ALLEGHENY COUNTY SANITARY AUTHORITY

CONTRACT NO. 1739 G & E

ELECTRICAL DISTRIBUTION SYSTEM UPGRADE

ADDENDUM NO. 1

ALLEGHENY COUNTY SANITARY AUTHORITY
 WASTEWATER TREATMENT PLANT
 ELECTRICAL DISTRIBUTION SYSTEM UPGRADE
 000-FS-02
**LAN FIBER / TELEPHONE SYSTEMS
 INSTALLATIONS SCHEMATIC ROUTING PLAN**

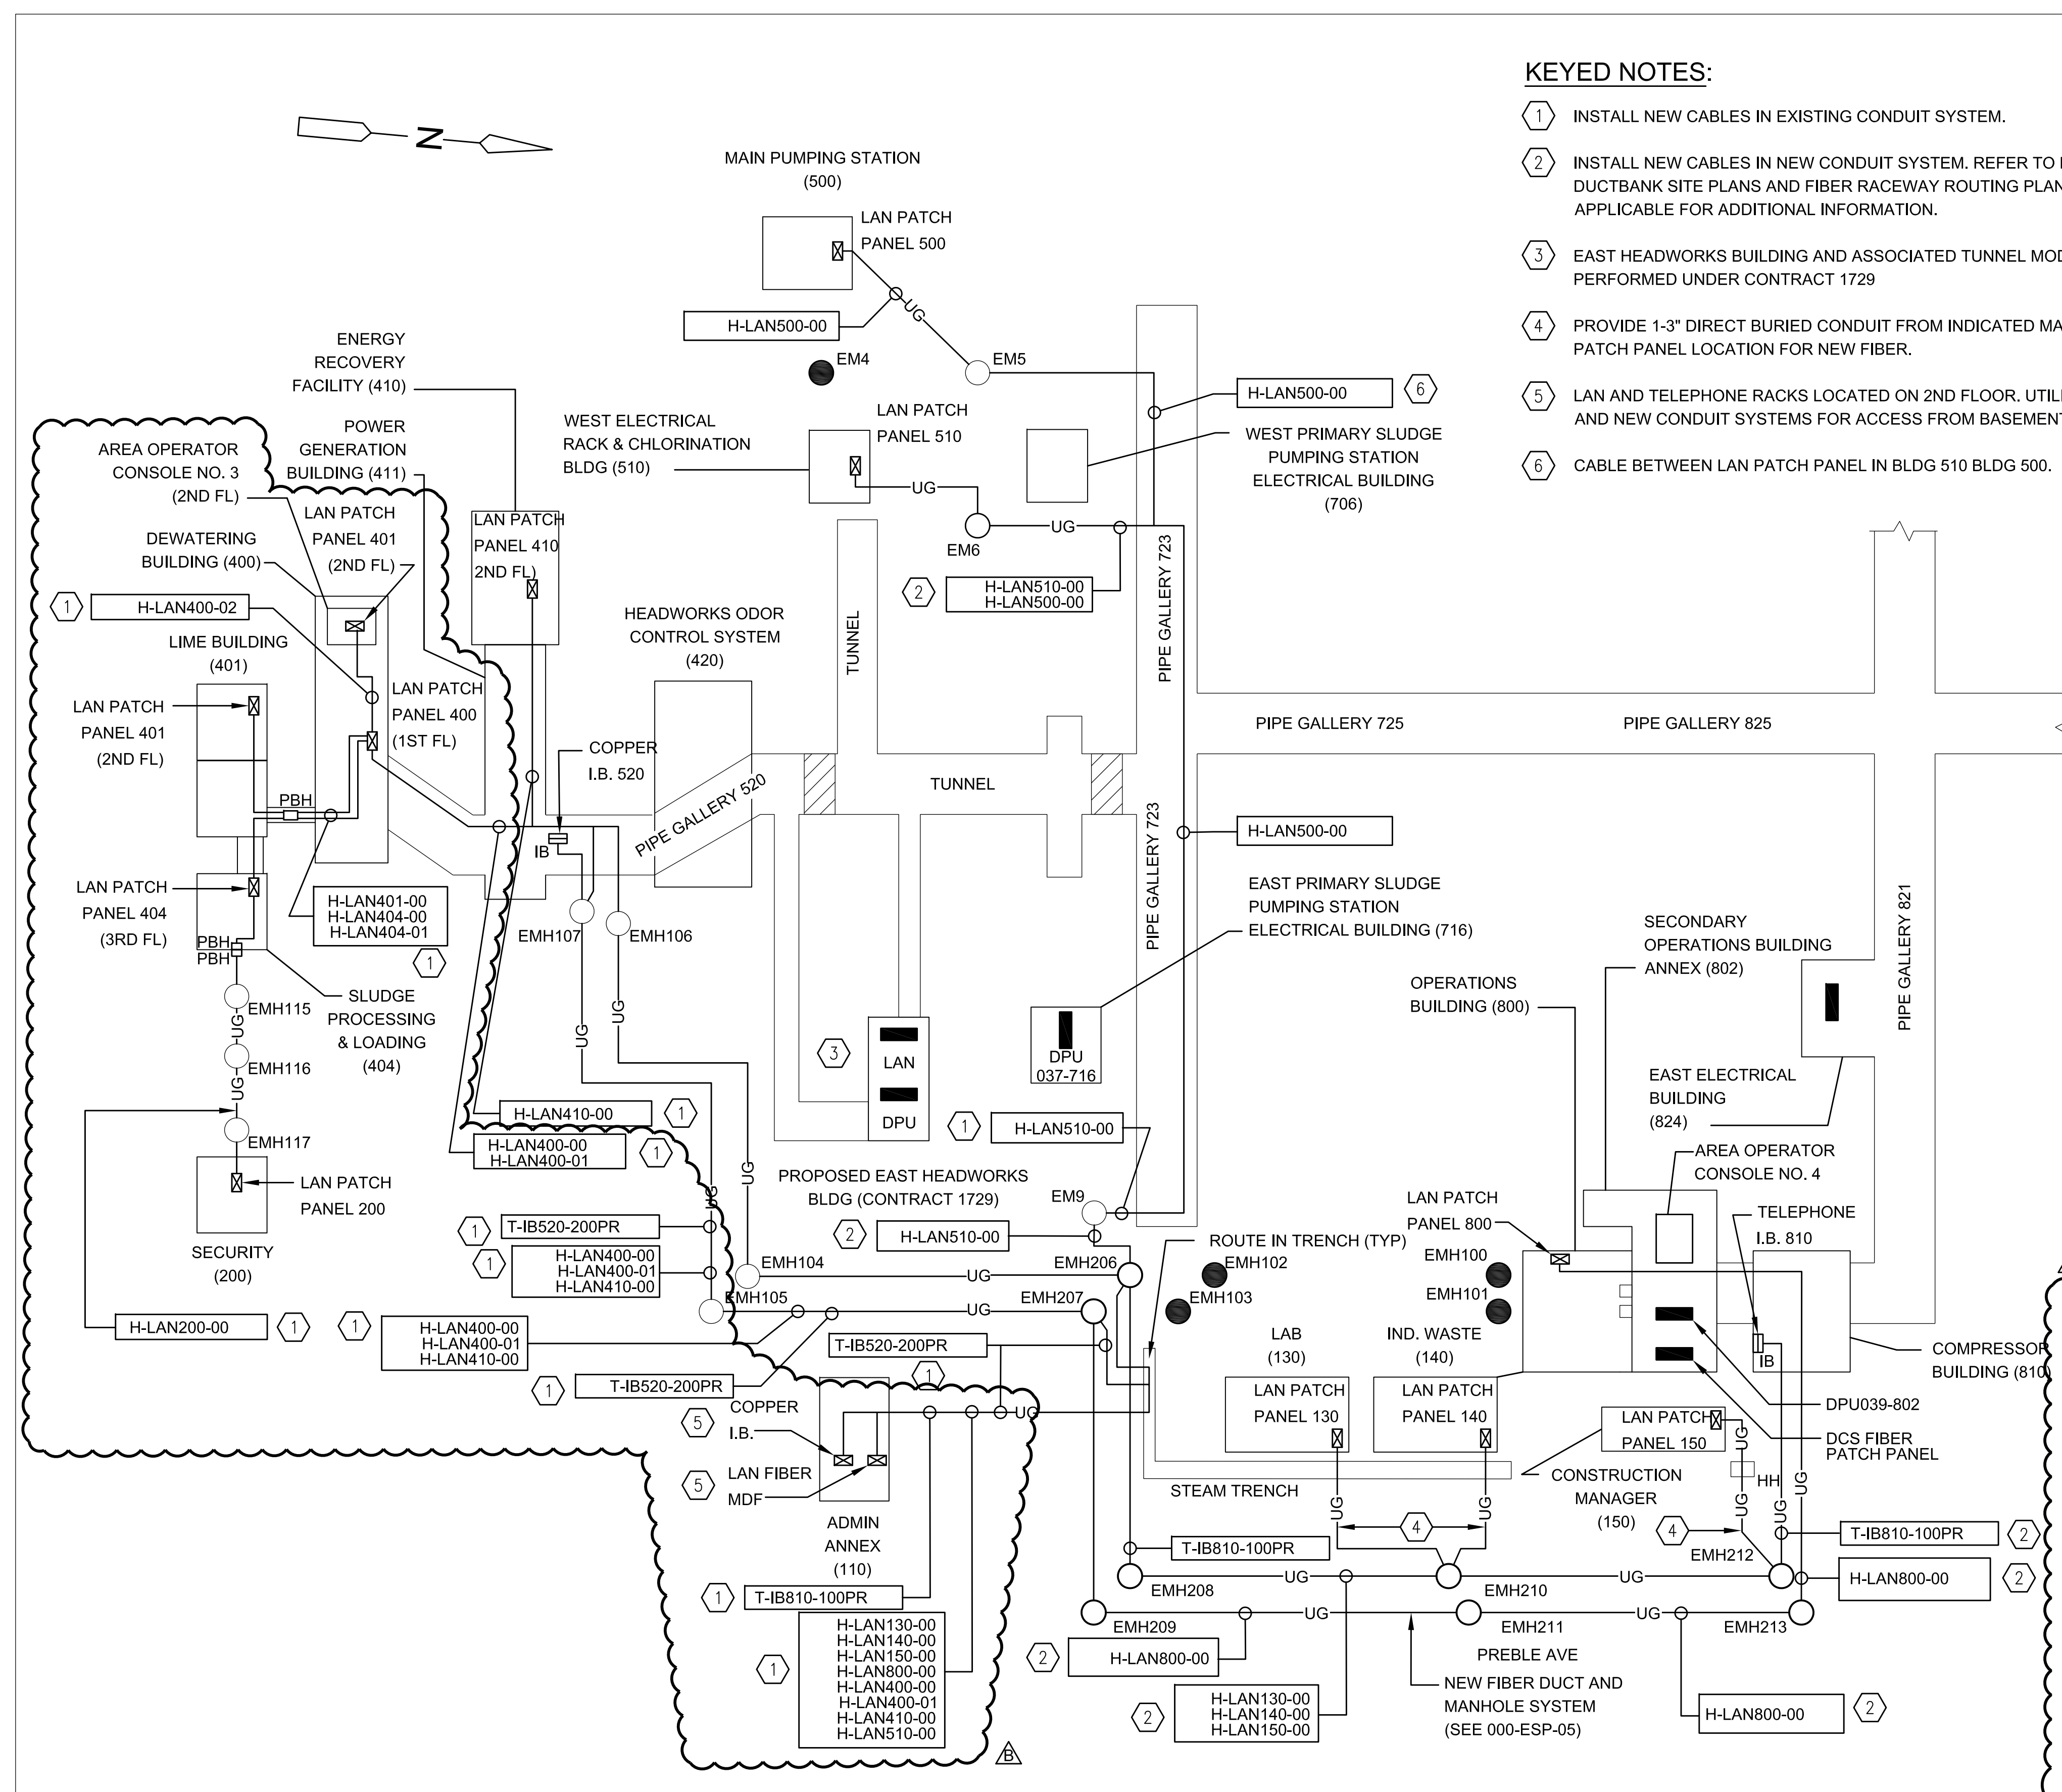
17.000-FS-02

- a) Revisions to Bldg 400, 401, 404, and 200 fiber. Replace entire drawing with attached drawing.

CONTRACT 1739-ADDENDUM NO. 1
 REFERENCE PARTIAL SITE PLAN FOR FIBER TO BLDG 200

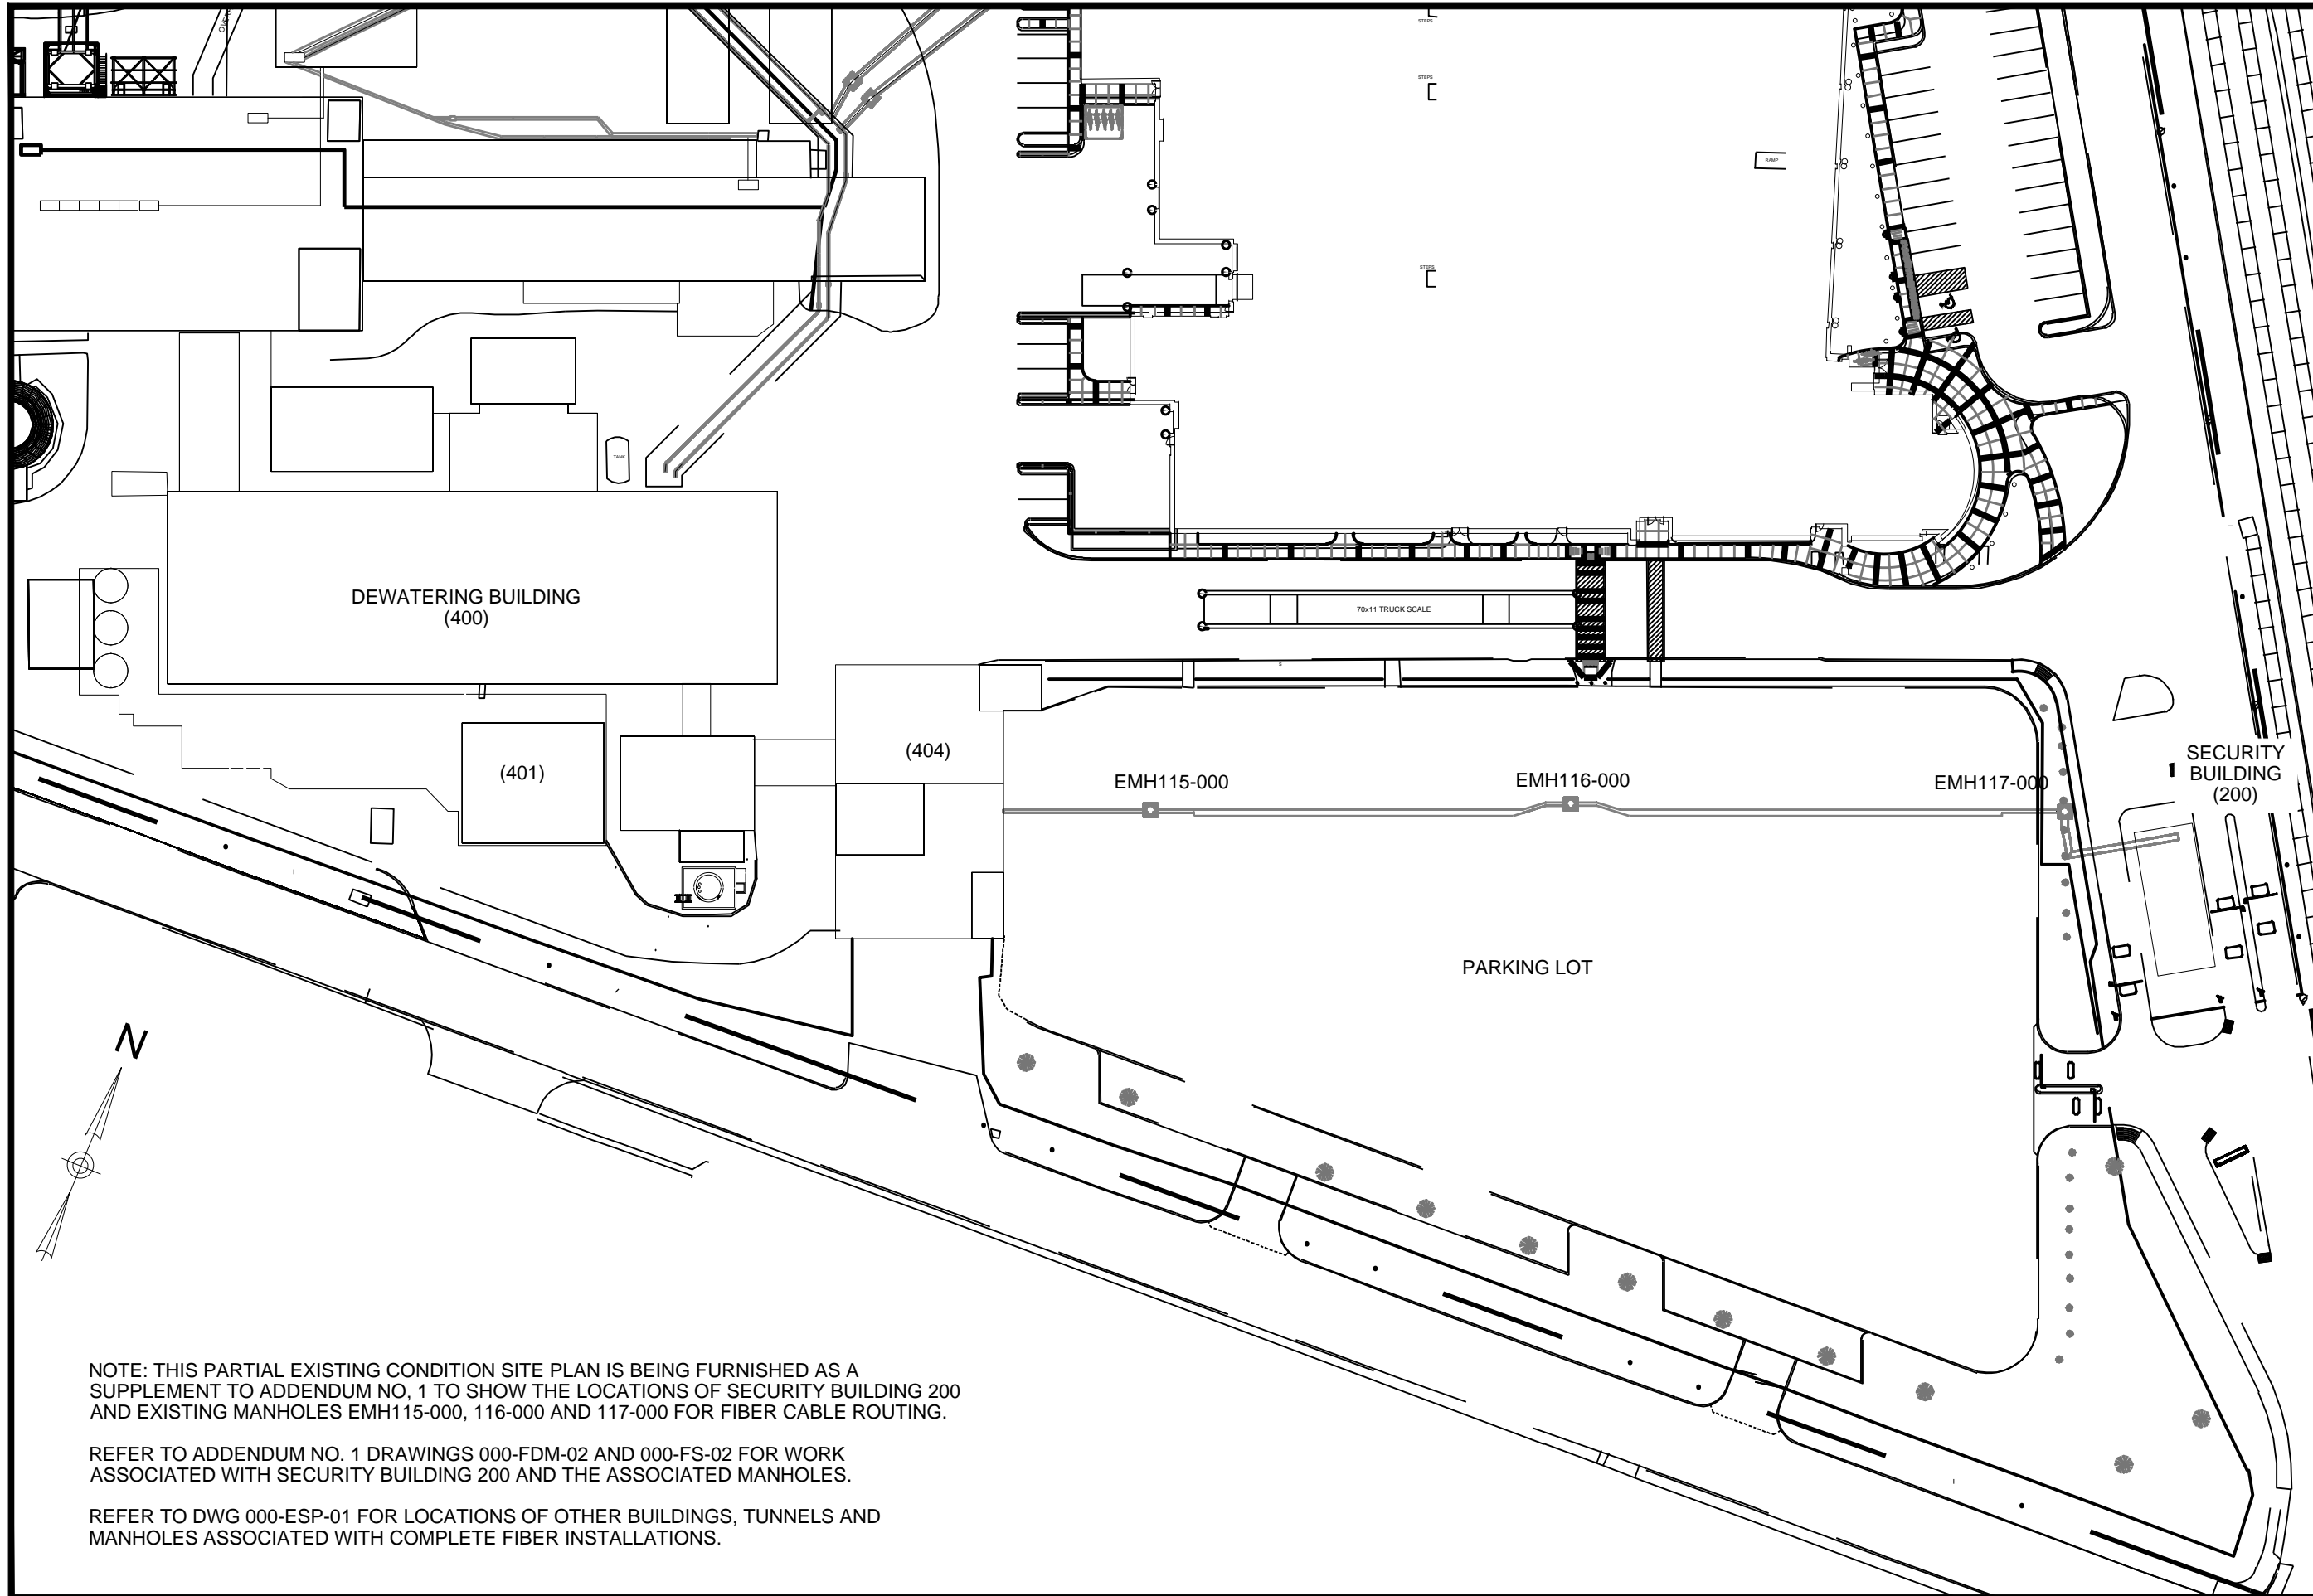
NOTE: THIS PARTIAL EXISTING CONDITION SITE PLAN IS BEING FURNISHED AS A SUPPLEMENT TO ADDENDUM NO. 1 TO SHOW THE LOCATIONS OF SECURITY BUILDING 200 AND EXISTING MANHOLES EMH115-000, 116-000 AND 117-000 FOR FIBER CABLE ROUTING.
